186th session

Proposal for Supplement 11 to UN Regulation No. 109 (Retreaded tyres for commercial vehicles and their trailers)

Submitted by the Working Party on Noise and Tyres*

Figure, amend to read:

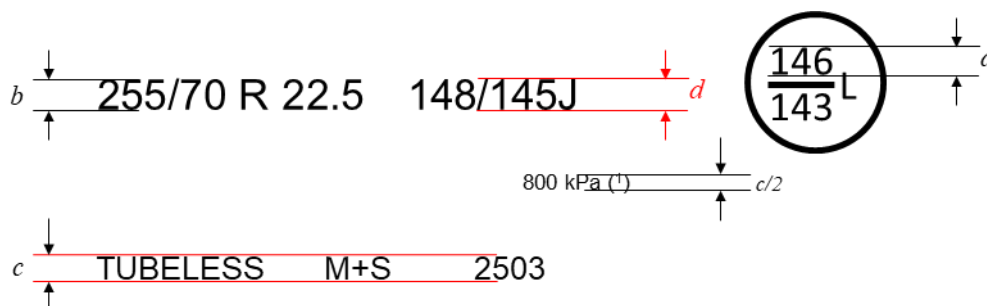
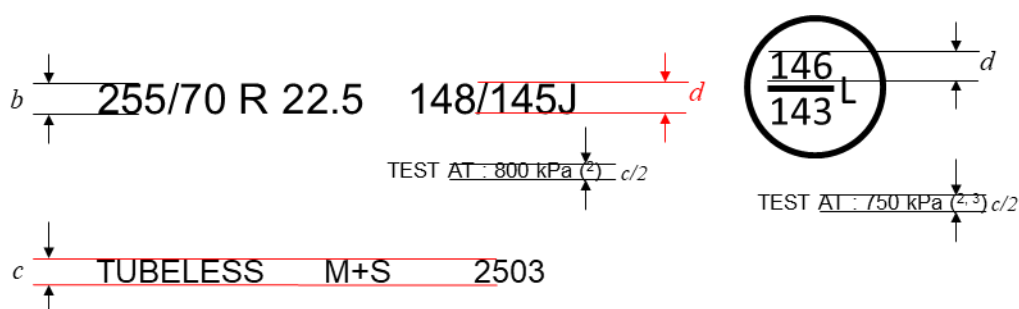
Annex 3,

- (1) PSI marking instead of kPa is allowed for tyres first type approved before 1 January 2018. The kPa marking may be preceded by "TEST AT : " or, alternatively, by "TEST INFL : " or the symbol "@".

- (2) "TEST AT : " may be replaced by "TEST INFL : " or the symbol "@" or be omitted.
 (3) The indication of a second inflation pressure for the additional service description is optional. If there is no indication, the same test inflation applies to both load/speed combinations.

Dimensional requirements for further markings (4):

- (4) For "ML" and "MPT" being part of the tyre size designation marking the minimum dimension *b* applies."
